## TECHNICAL MEMORANDUM

**PROJECT #:** 727.07 Task 01 (P19-0061)

**SUBJECT:** Artz Wetland Revised Report Review – West parcel

Figure 2. City of Puyallup mapping, showing wetlands, streams and floodplains.

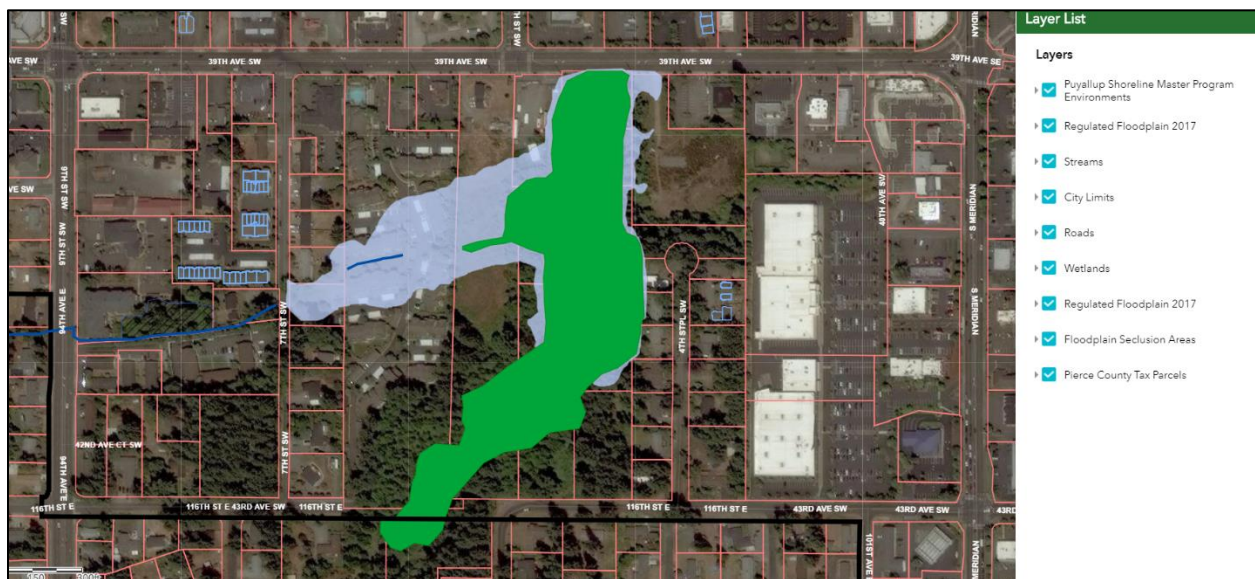
- Please provide a topography base map for future site plan submittals.
- Ideally, the report figures would also include the Floodplain mapping, as depicted in Figure 2 below, but as the development does not infringe on the floodplain, the lack of this Figure in the report is acceptable.
